# PLATTE SELF STORAGE

## GRADING AND EROSION CONTROL PLAN

### OVERVIEW SHEET

AUGUST 2024

**STORM SEWER MAIN RUN - PLAN & PROFILE**  
 HORZ SCALE: 1"=40' - VERT SCALE: 1"=4'

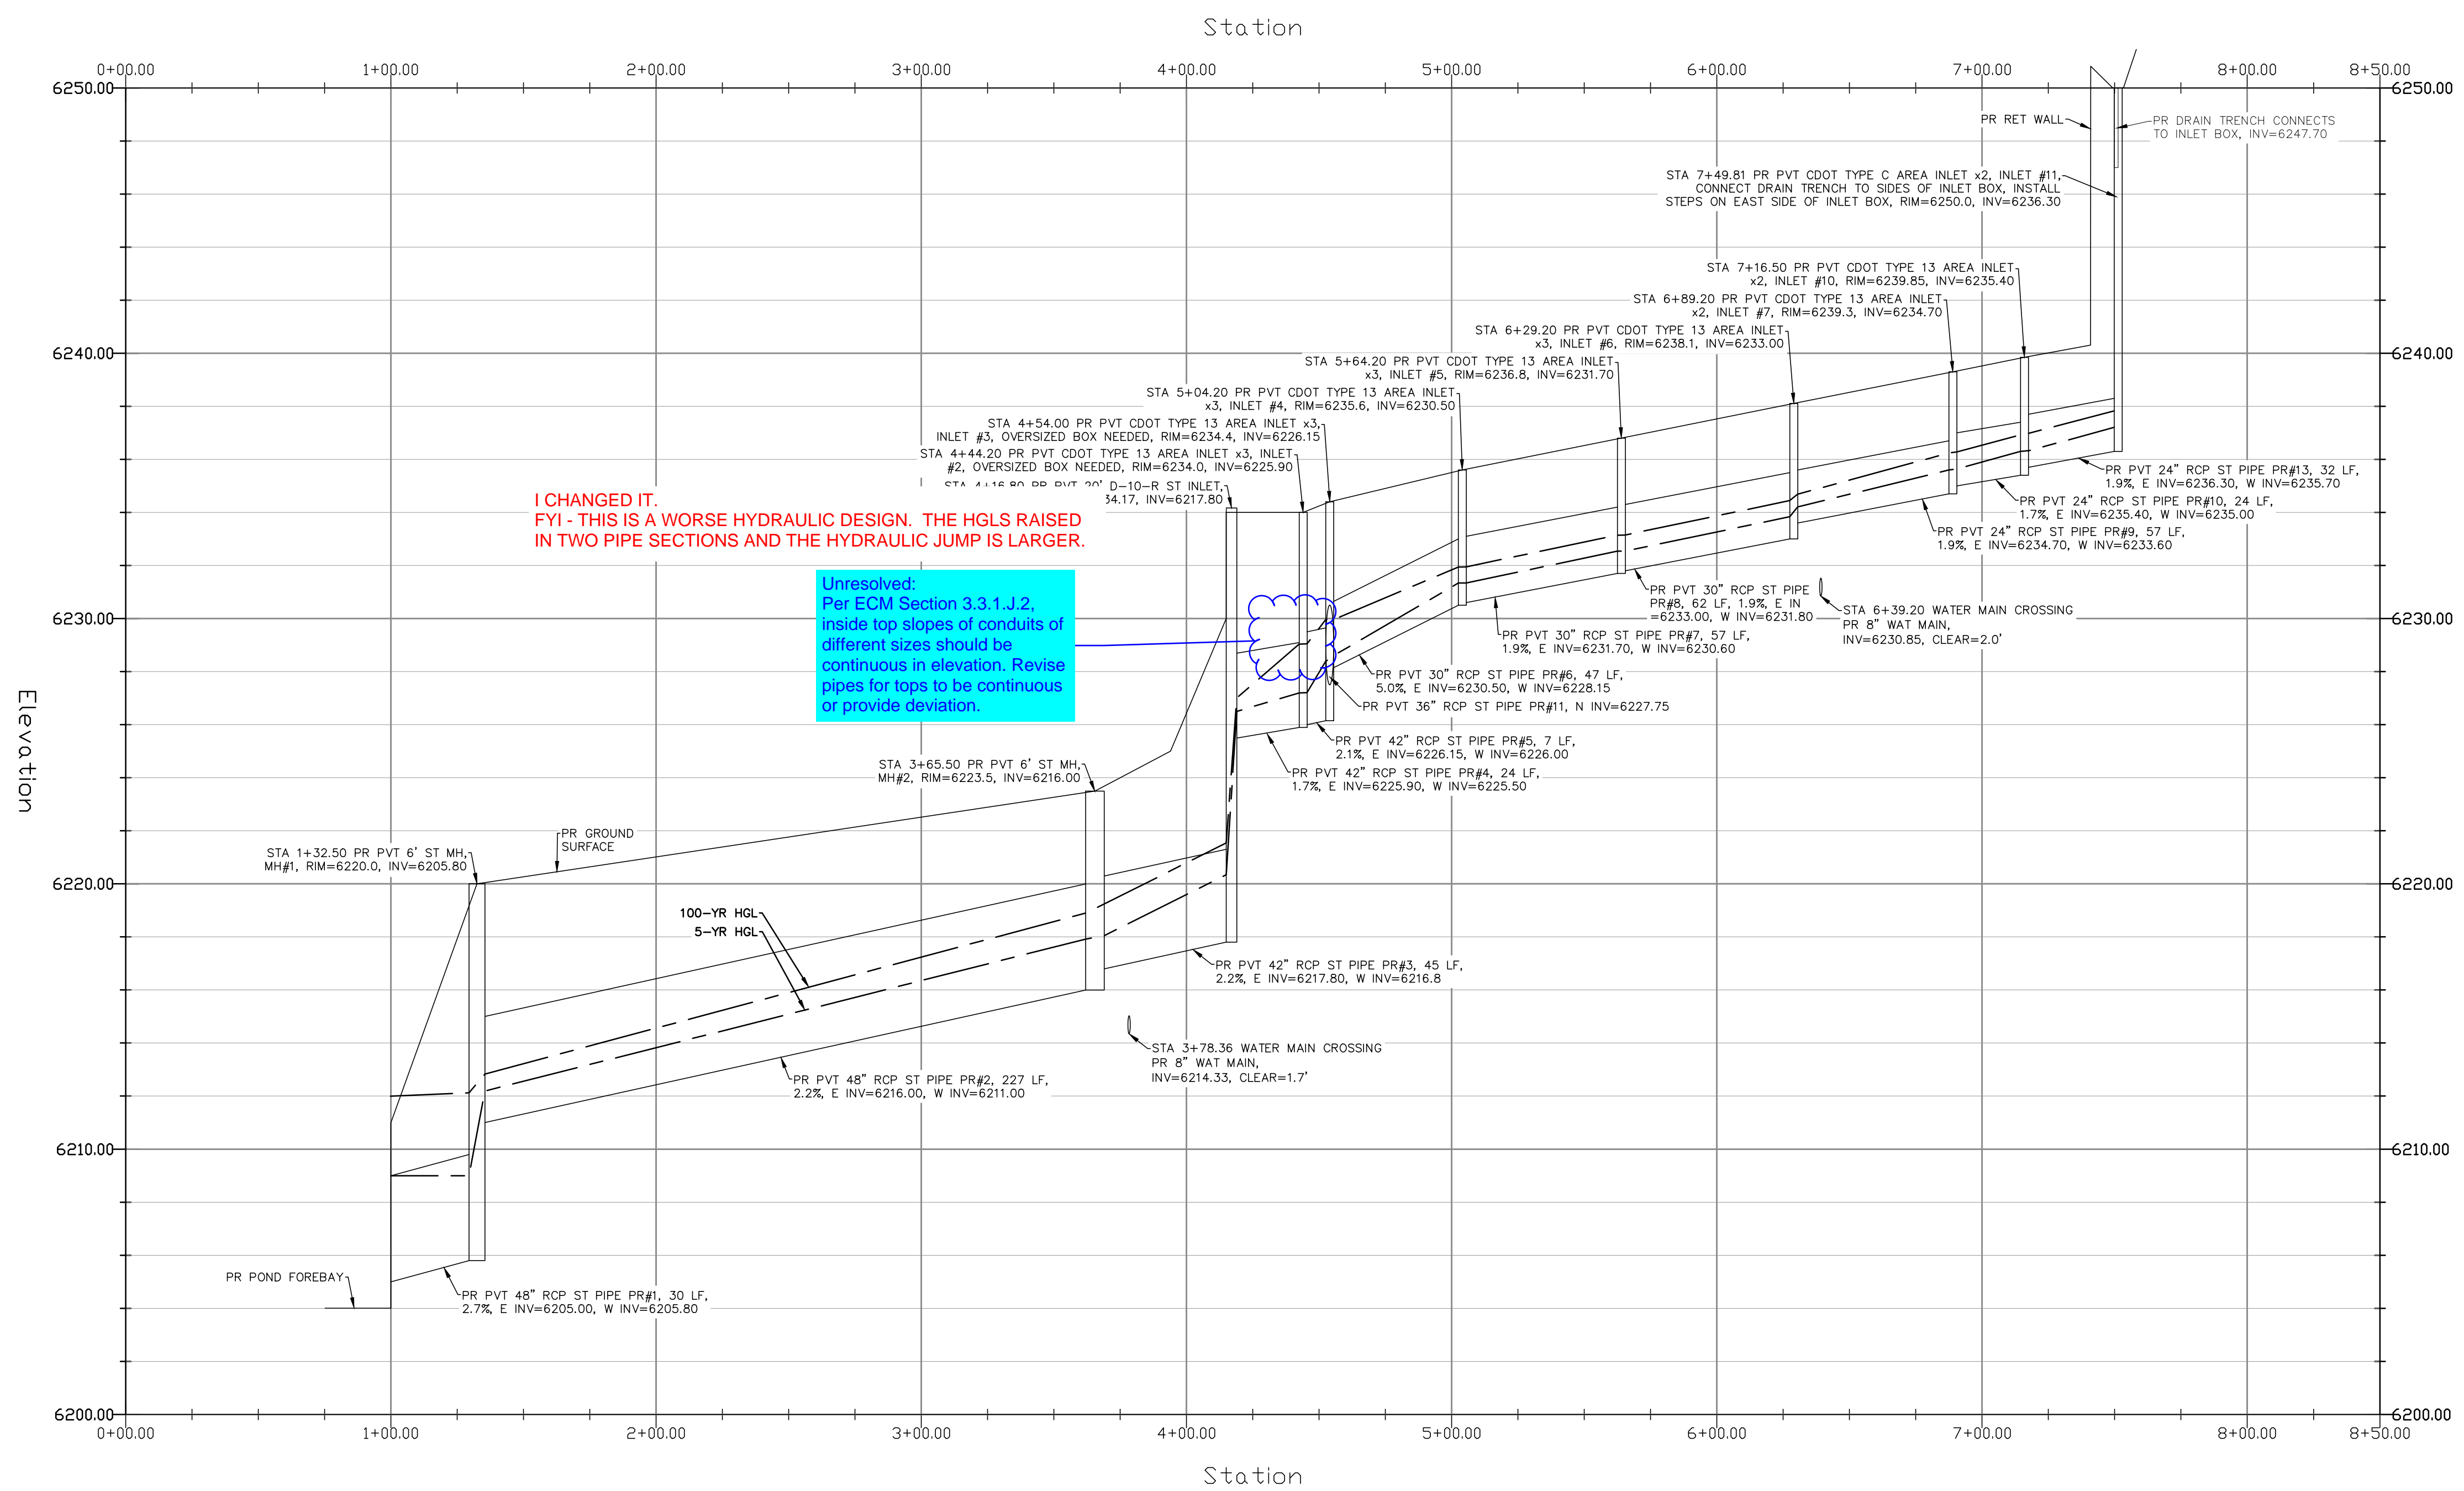
**Unresolved:**  
 Per ECM Section 3.3.1.J.2, inside top slopes of conduits of different sizes should be continuous in elevation. Revise pipes for tops to be continuous or provide deviation.

**I CHANGED IT. FYI - THIS IS A WORSE HYDRAULIC DESIGN. THE HGLS RAISED IN TWO PIPE SECTIONS AND THE HYDRAULIC JUMP IS LARGER.**

**SECTION C-C**  
NOT TO SCALE

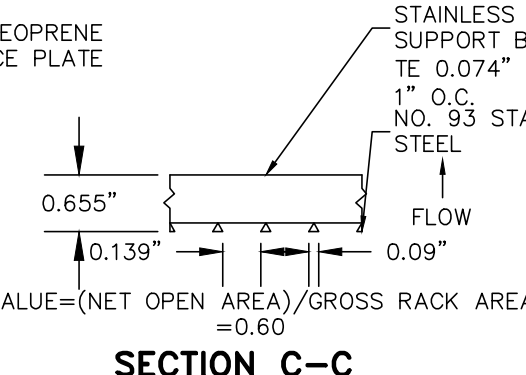
Unresolved: Per DCMV1 Chap 11.3.3, adjust pond design to include a min. width of 12ft at top of embankment.

THIS WIDTH HAS BEEN EXTENDED TO 12', BUT THE CALLOUT WAS NOT UPDATED.

### EXTENDED DETENTION BASIN PLAN

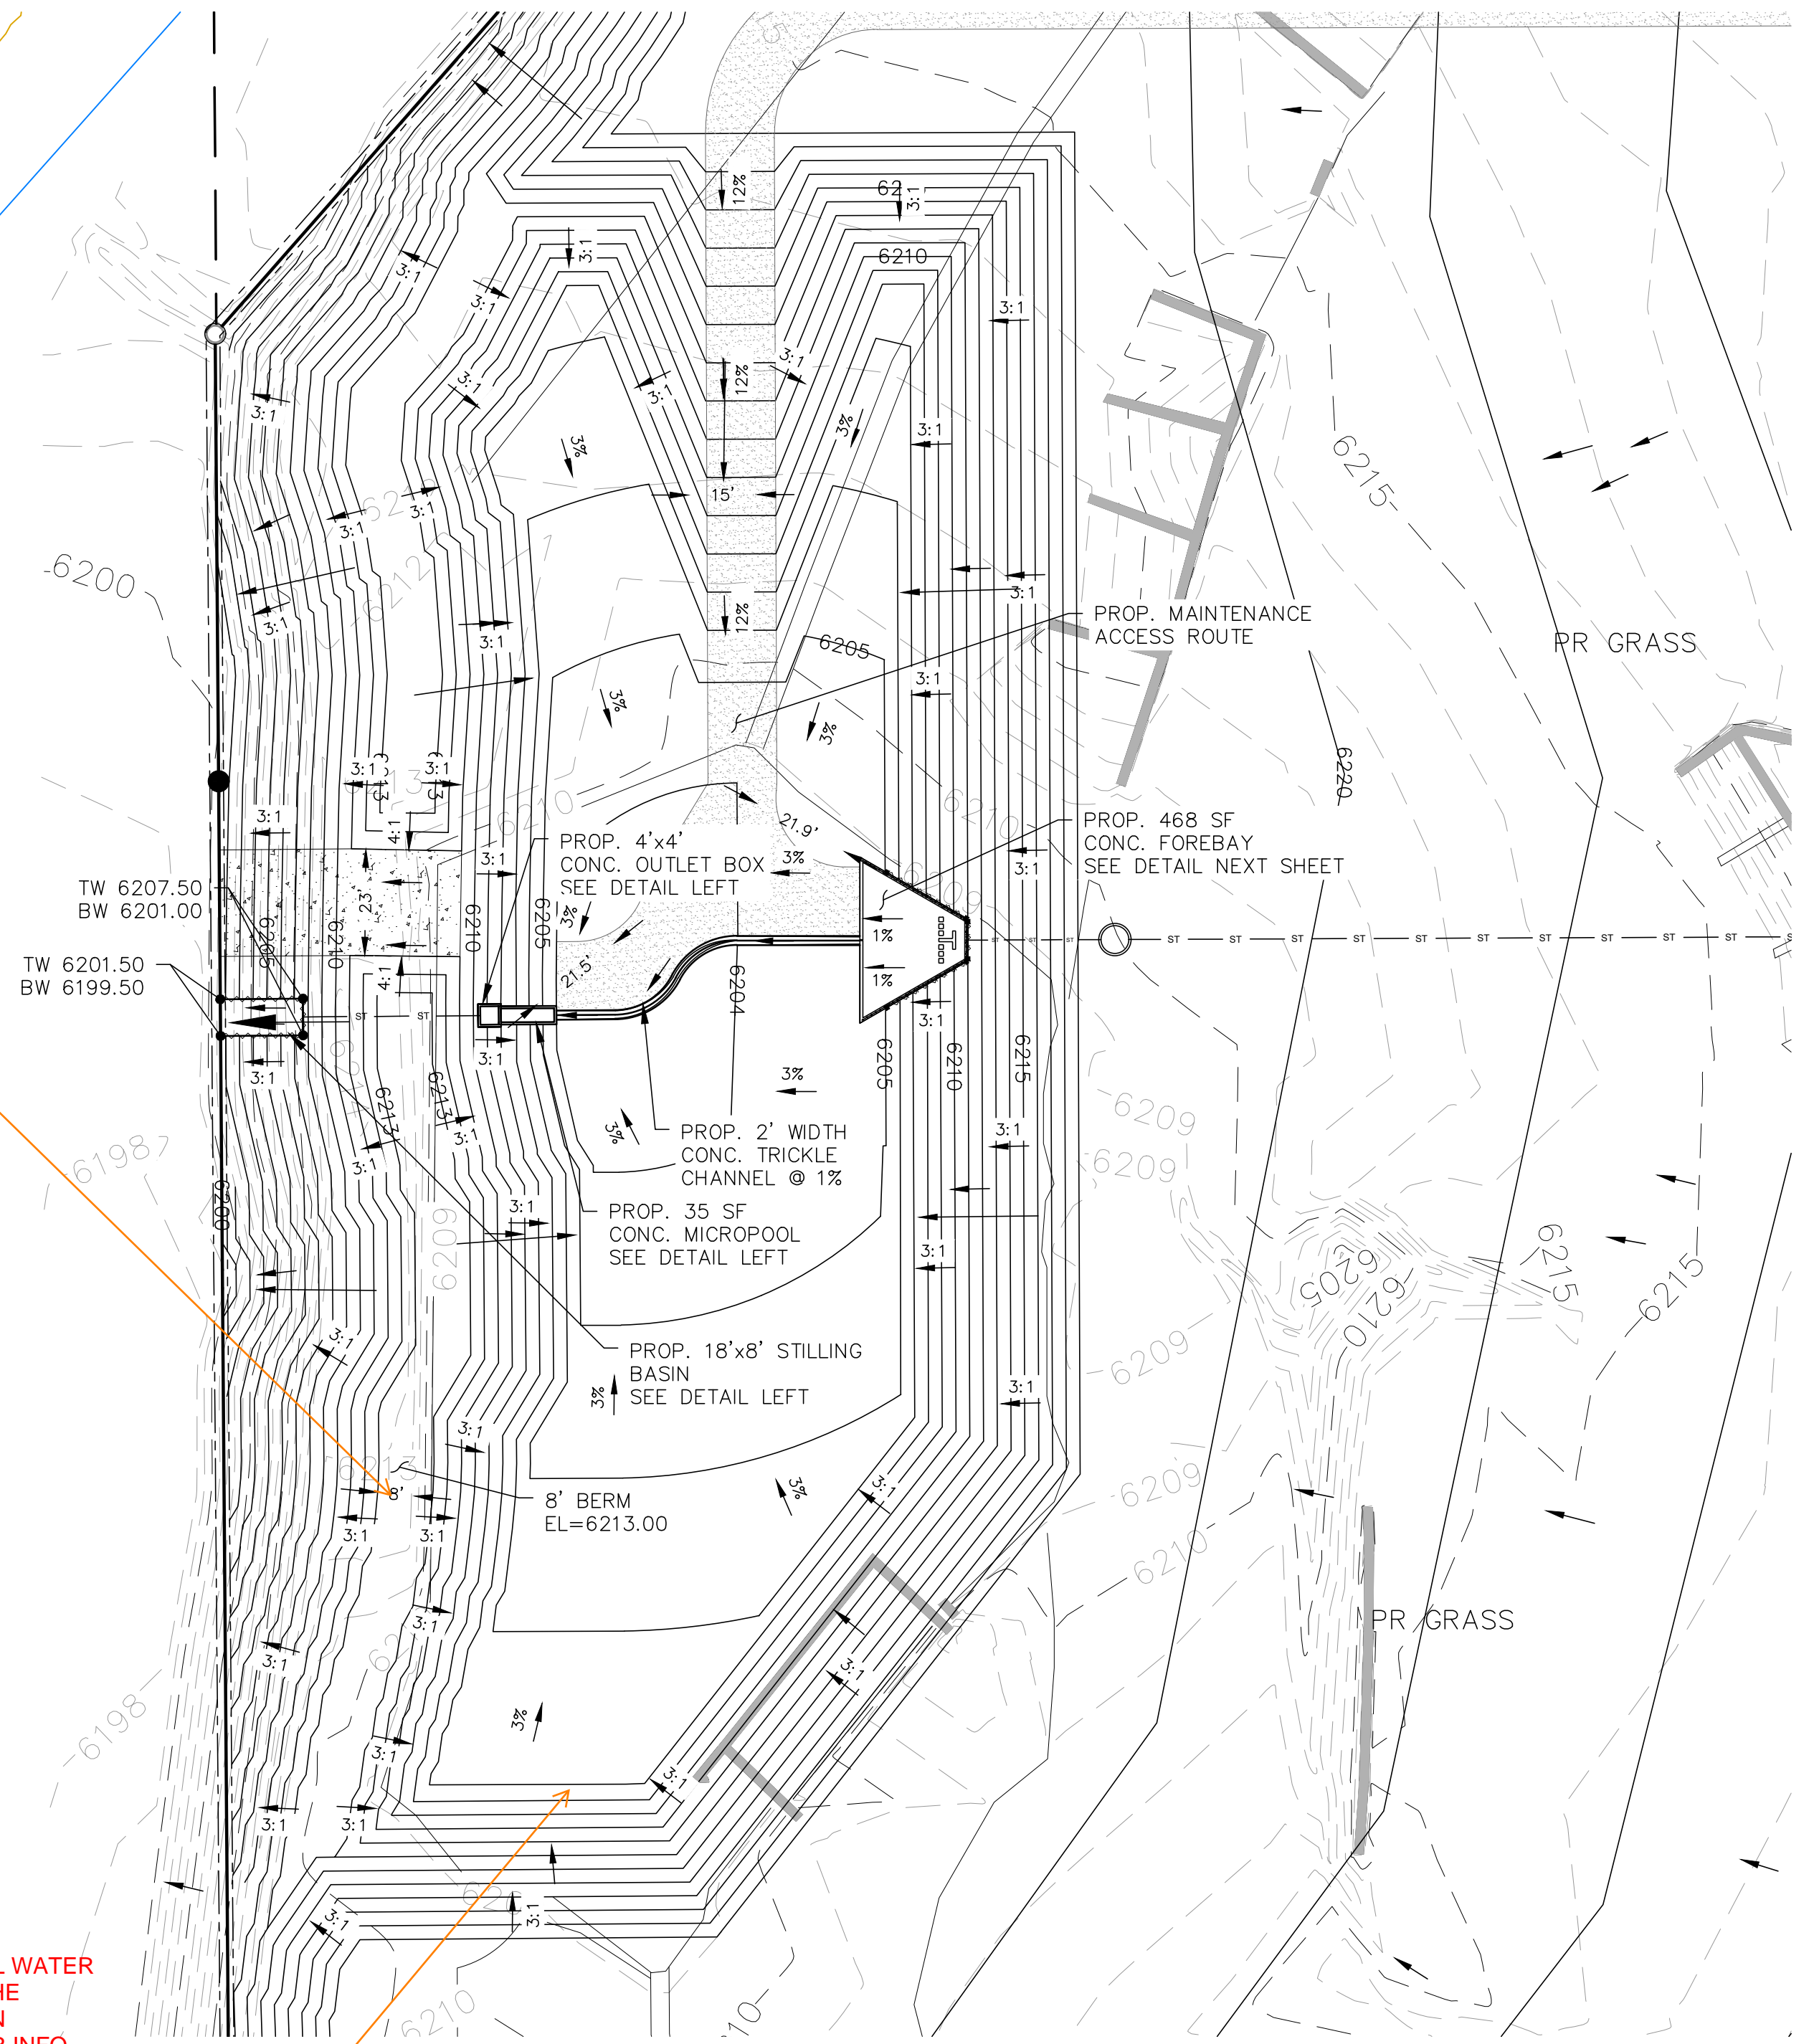
Unresolved from Submittal 1: This pond is deeper than 10-ft and likely qualifies as a state jurisdictional dam. At a minimum it would qualify as a non-jurisdictional water impoundment structure. Either submit jurisdictional or non-jurisdictional water impoundment structure application.

NON-JURISDICTIONAL WATER APPLICATION IS IN THE WORKS. WE'VE BEEN WAITING FOR OWNER INFO SINCE THE 1ST COMMENTS.
